**Addendum to
User's Guide**

HP StorageWorks ESL E-Series 322e and 286e Tape Libraries

Addendum to HP StorageWorks ESL E-Series Tape Libraries User's Guide

Part Number: 372534-001

Figure 1: Location of slots in the 322e and 286e tape libraries

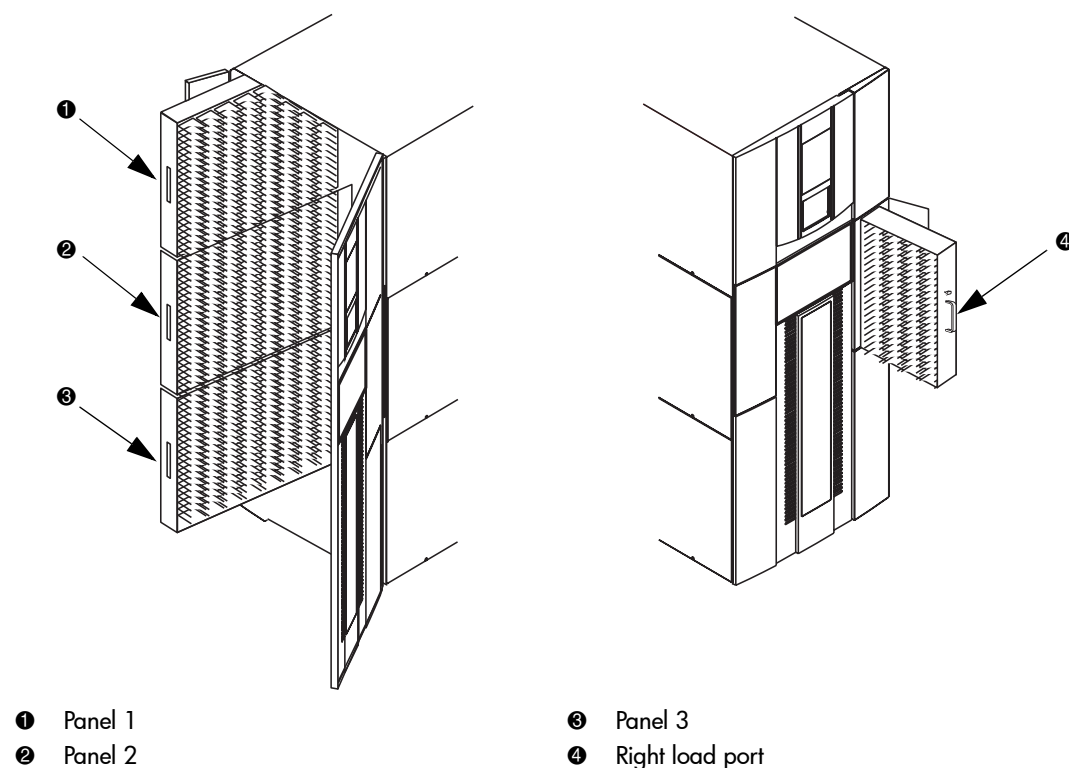
- Slot capacity for the Model 322e (Ultrium) library is 324. The left load port capacity is 18; the right load port capacity is 36.
- Slot capacity for the Model 286e (SDLT) library is 288. The left load port capacity is 16; the right load port capacity is 32.
- Slots are located in panels 1, 2, and 3 only, which are on the left as you face the front of the library (see [Figure 1](#)).

- HP strongly recommends you enable the right load port only (see [Figure 1](#)). If the right load port is enabled, no slots are reallocated; the library slot count and slot numbering remains the same.

Caution: For firmware 1.10 only, if the left load port is enabled, slots 307-324 in the 322e or slots 273-288 in the 286e are moved to panel 4 from panel 3 to preserve the total number of storage slots. If disabling the left load port or upgrading the firmware, be sure that the slots in panel 4 are empty because they will become inaccessible, stranding any media remaining in those slots.
